A CENTERCAL DEVELOPMENT

NYBERG RIVERS MASTER PLAN

TUALATIN, OREGON

Figure 2: City Access Crossing Diagram

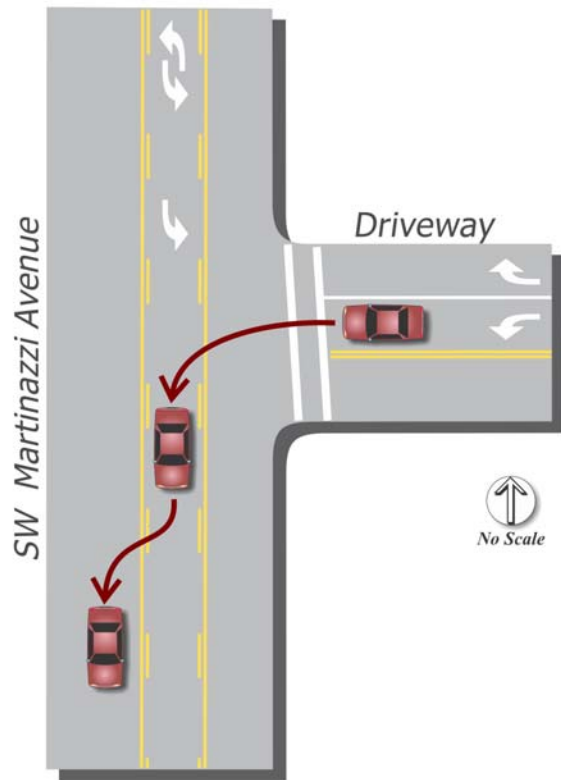
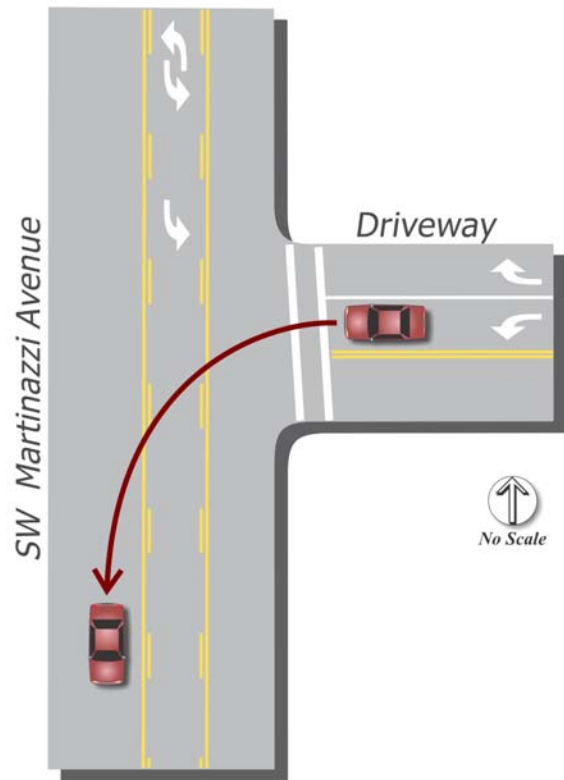
The City Access Driveway (shown as Driveway 1 in Figure 1) was further analyzed in relation to the need to build a signalized SW Seneca Street extension to serve the proposed development. In particular, the City requested a deeper understanding of Scenario 2 regarding the interaction between the operational results of the City Access Driveway when the Seneca Street extension is not built, but Driveway 2 remains closed. The City specifically wanted to know whether the use of the volumes presented by the applicant in the April 2013 TIA or the volumes proposed in Attachment B of this memorandum would change the resulting need to build or not build the Seneca extension. In further researching this issue, it was determined that the use of the April 2013 TIA or Attachment B volumes do not create a difference in results. What does impact the results is the consideration of a two-stage or a one-stage crossing for westbound left turns leaving the site.

A one-stage crossing assumes that vehicles making a westbound left turn from the city access would cross both the northbound lane and the two-way center left turn lane and merge into the southbound lane in one movement. This would require gaps in both northbound and southbound traffic before vehicles can complete their turning movement and results in larger delay values as vehicles wait for an opening. A two-stage crossing assumes vehicles making the westbound left would first identify a gap in the northbound traffic and cross to the two-way center left turn lane. There they would position themselves and wait for a gap in the southbound traffic before completing their turning movement. Figure 2 illustrates the difference in maneuvers.

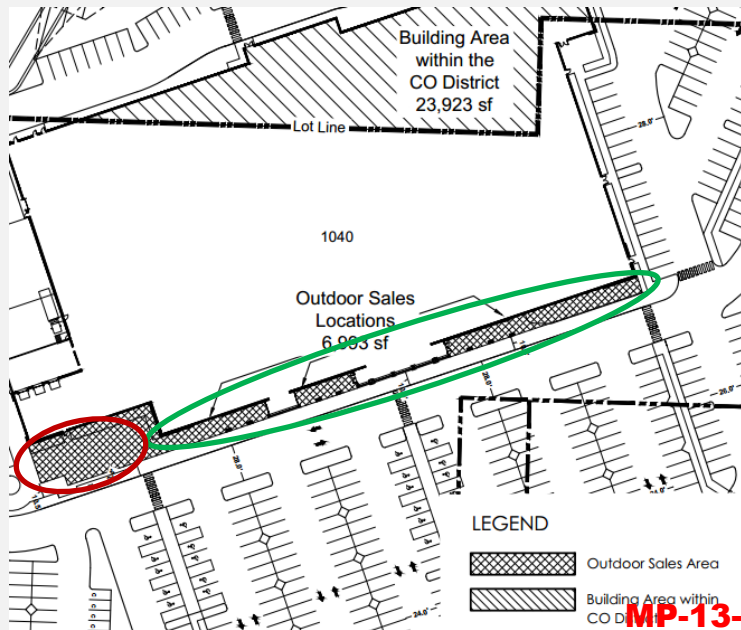
Recreational equipment, apparel and sports outfitting sales are prohibited in the public gathering place identified below.

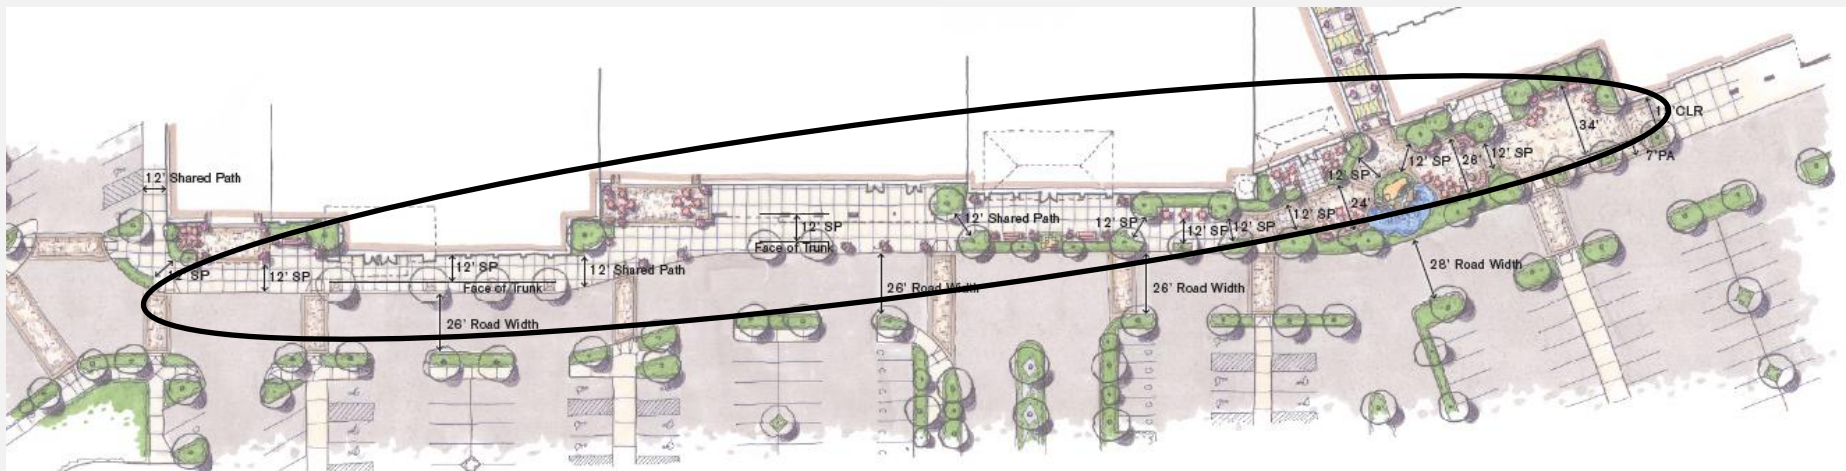
The proposed “outside sales areas” should be configured to provide a minimum of 12 feet in clear, unobstructed width for public gathering spaces, accessways and walkways measured from the edge of an “outside sales area”, and;

A minimum of 12 feet of clear, unobstructed width for walkways or accessways through a plaza or along the building frontage between Building D1 on the west and southeast corner of Building 1040 on the east northwest corner of the public gathering, multi-function open plaza and plaza seating with fire pit on Attachment 102D page 60 Building Frontage landscape plan.

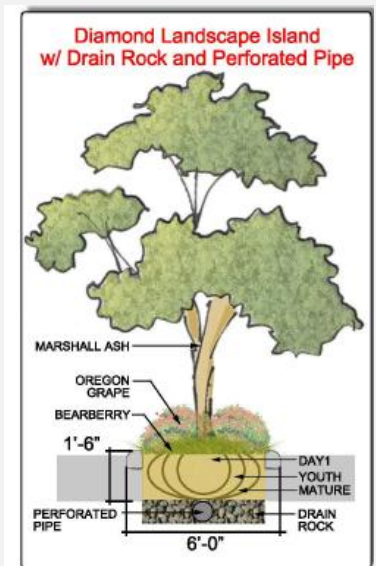
Are “diamond-style” planter areas sufficient to meet landscaping requirements?
